Groundwater Application Review Summary Form

Application # G- 18518

To: Kristopher Byrd, Well Construction and Compliance Section Manager
From: Joel Jeffery, Well Construction Program Coordinator
Subject: Review of Water Right Application G-18518
Date: September 19, 2018

PUBLIC INTEREST REVIEW FOR GROUNDWATER APPLICATIONS

Water-Level Trends in Nearby Wells

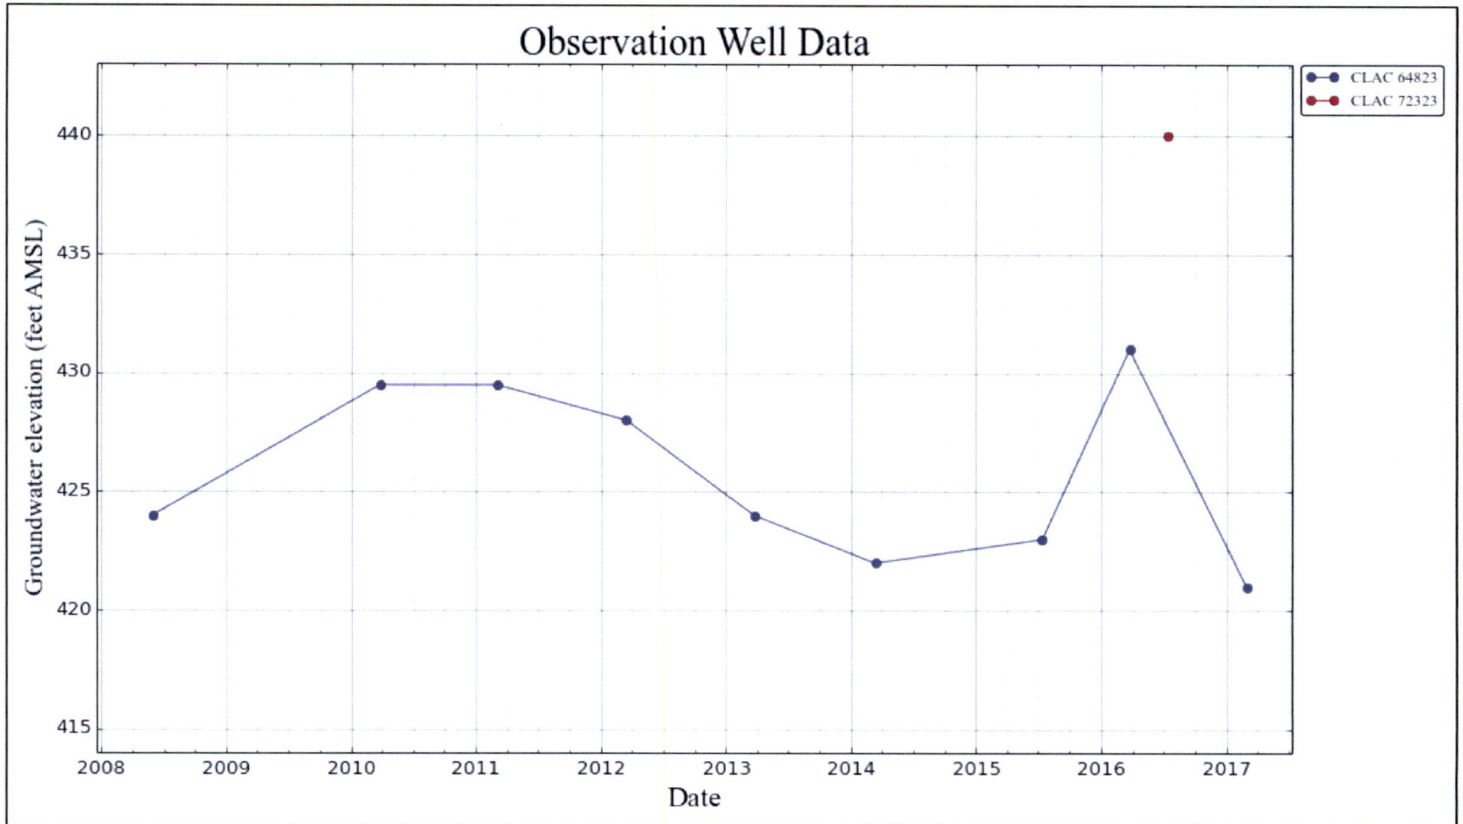
Nearby CLAC 64823 (0.8 miles away) displays reasonably stable water levels during the past decade. Groundwater elevation is nearly coincident with that reported in POA well CLAC 72323.
